LEGAL NOTICE EXETER PLANNING BOARD AGENDA

1 **TOWN OF EXETER**
2 **PLANNING BOARD**
3 **NOWAK ROOM – TOWN OFFICE BUILDING**
4 **10 FRONT STREET**
5 **OCTOBER 27, 2022**
6 **7:00 PM**
7 **DRAFT MINUTES**

Date: November 3, 2022
To: Planning Board
From: Dave Sharples, Town Planner
Re: W. Scott Carlisle III PB Case #17-26

We are in receipt of the conditions of approval dated August 25, 2017. The applicant hereby requests a Public Hearing as required in condition #2 to allow the Planning Board to review the design for the “TIF road” portion of the project. Review comments are listed below with our responses in bold.

DRAWING No. **A1**

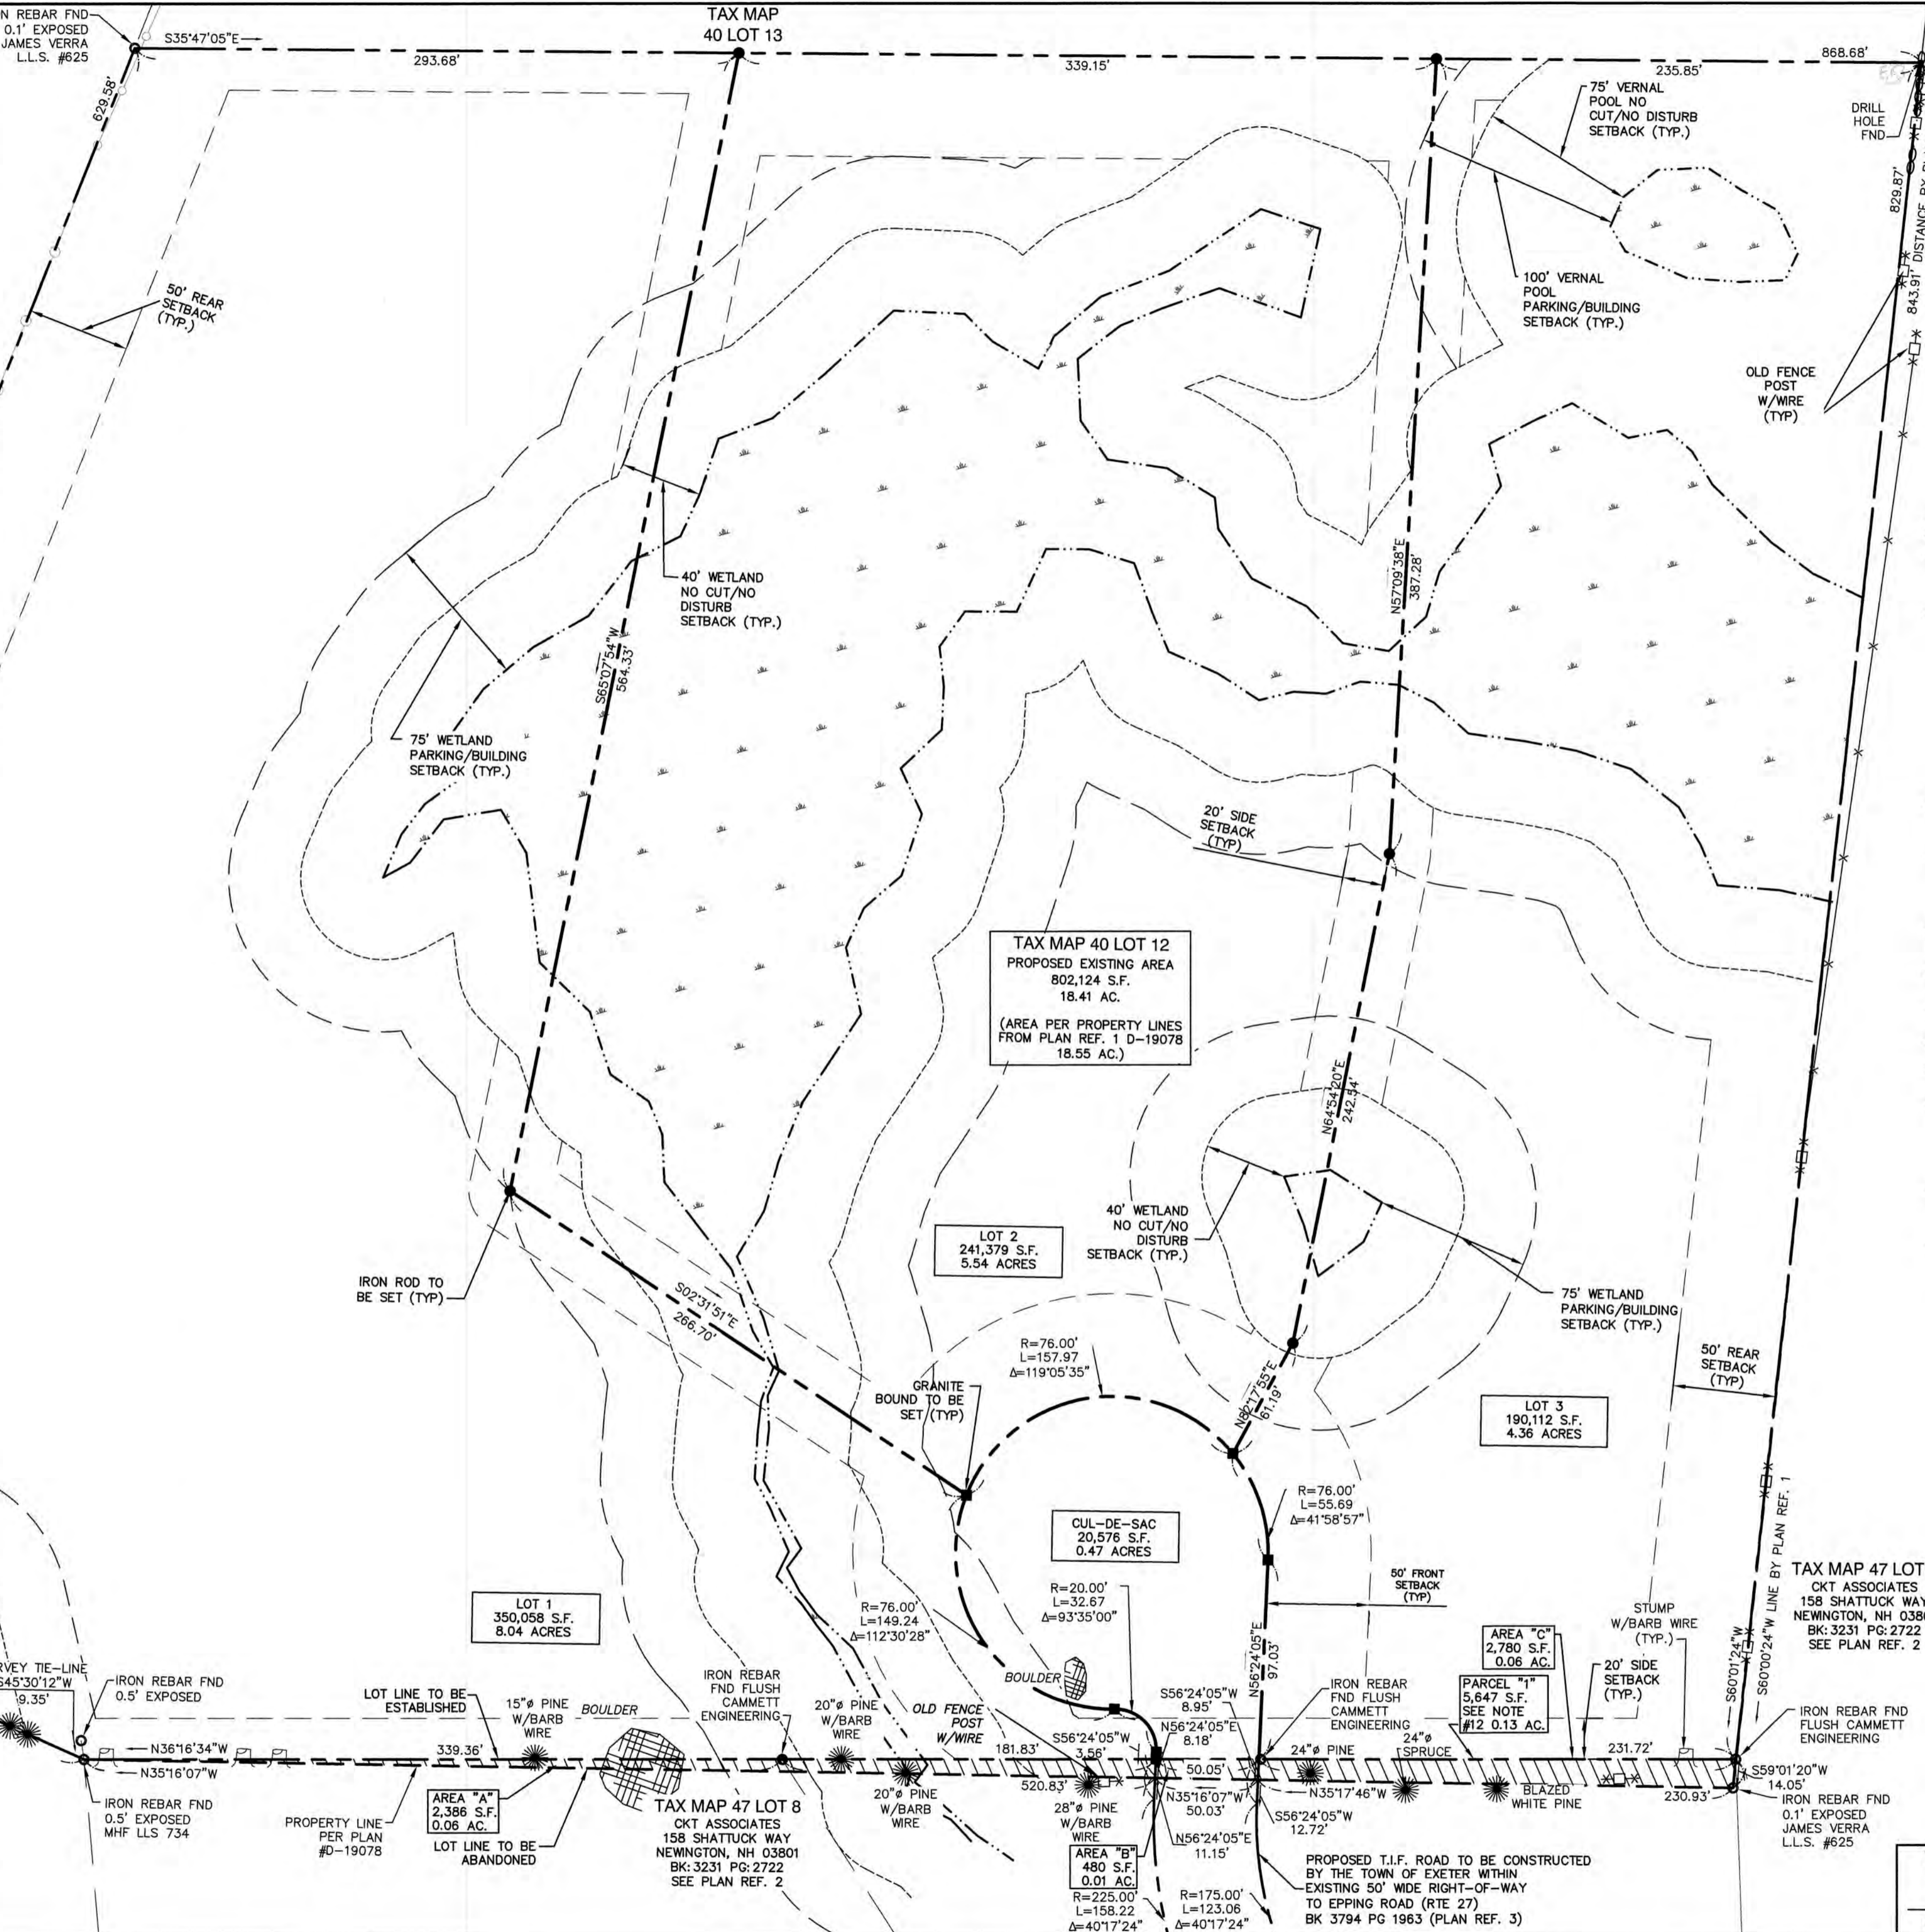
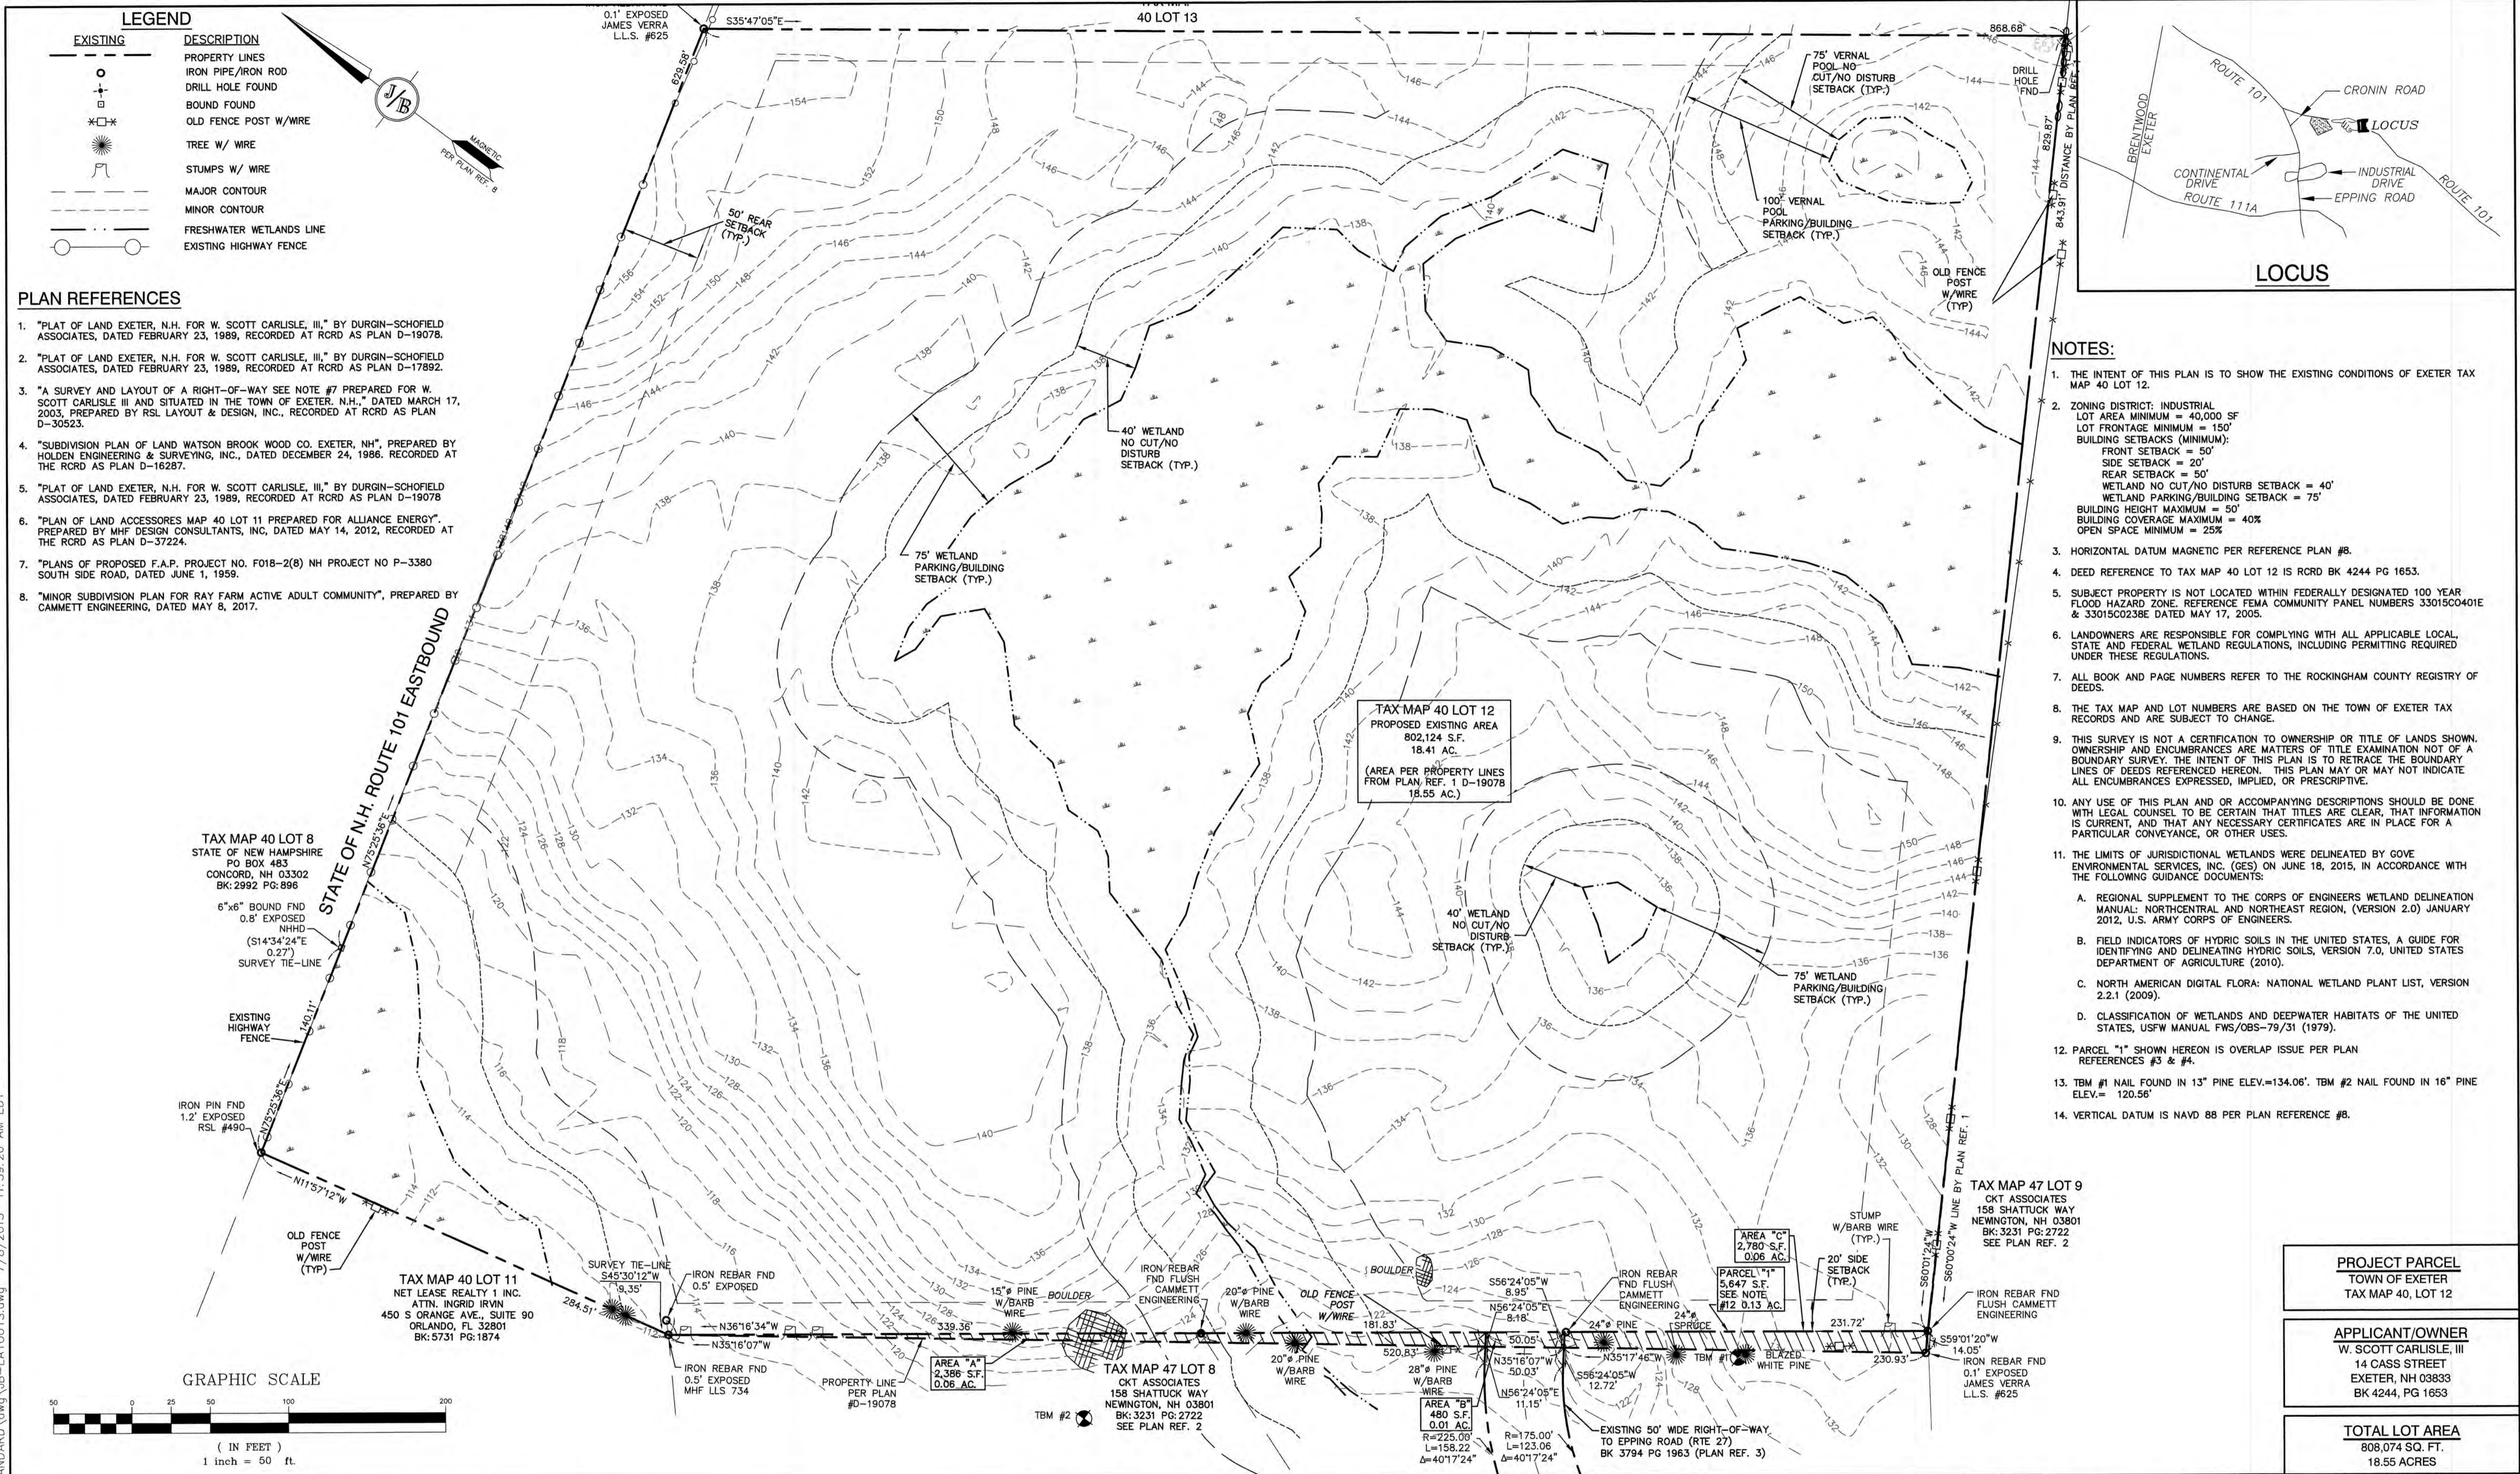
RESPONSE: The potential discrepancy regarding the location of the common boundary line between the subject parcel and the abutting parcel has been resolved. The applicant has elected to depict a Lot Line Adjustment granting the area in contention to the abutting parcel. The area to be transferred to Lot 8 is depicted as Parcel “1” on sheet A1, attached.
